**LOUISIANA
POWER & LIGHT**

SUBJECT: Waterford 3 SES
Docket No. 50-382
Comparison of Reactor Vessel PSI with
Regulatory Guide 1.150 Requirements

COMPARISON OF LP&L WATERFORD 3 PSE RPV EXAM TO NRC REGULATORY GUIDE 1.150 REQUIREMENTS

Figure 1

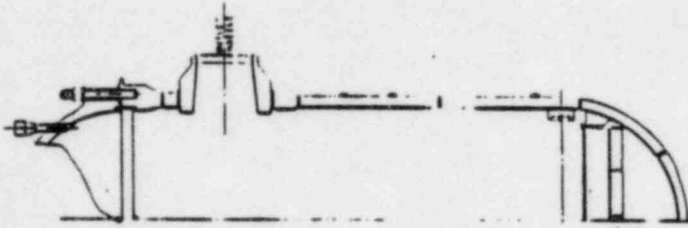
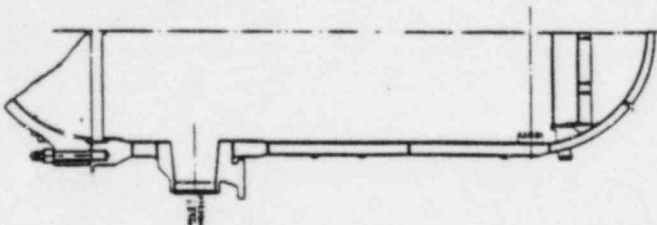
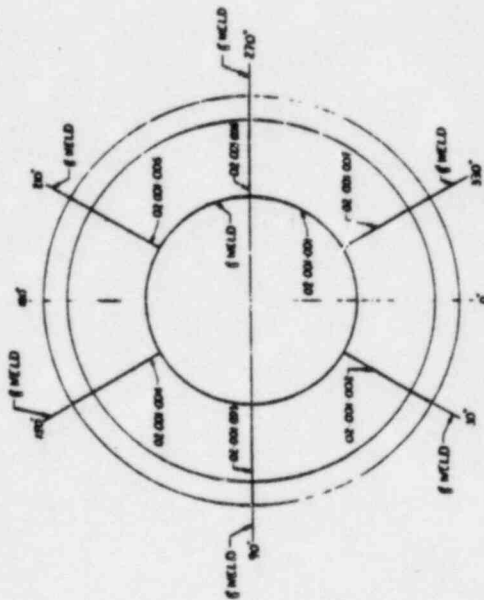
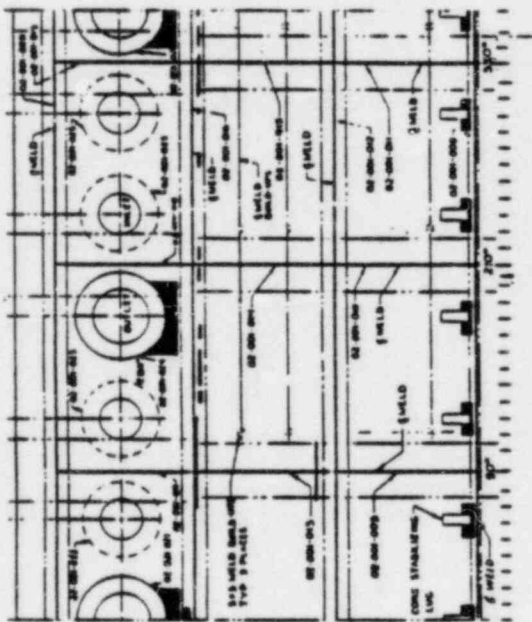
The outlet nozzle knuckle and the core stabilizing lugs are permanent physical limitations preventing access to some portion of the weld required volume (WRV). These areas are identified in the following table and figures. Other interferences, resulting in a lift-off situation, were caused by the vessel configuration or surface roughness. These areas are also identified in the following table and figures. Lift-off produces a spurious indication which is printed out on the paper.
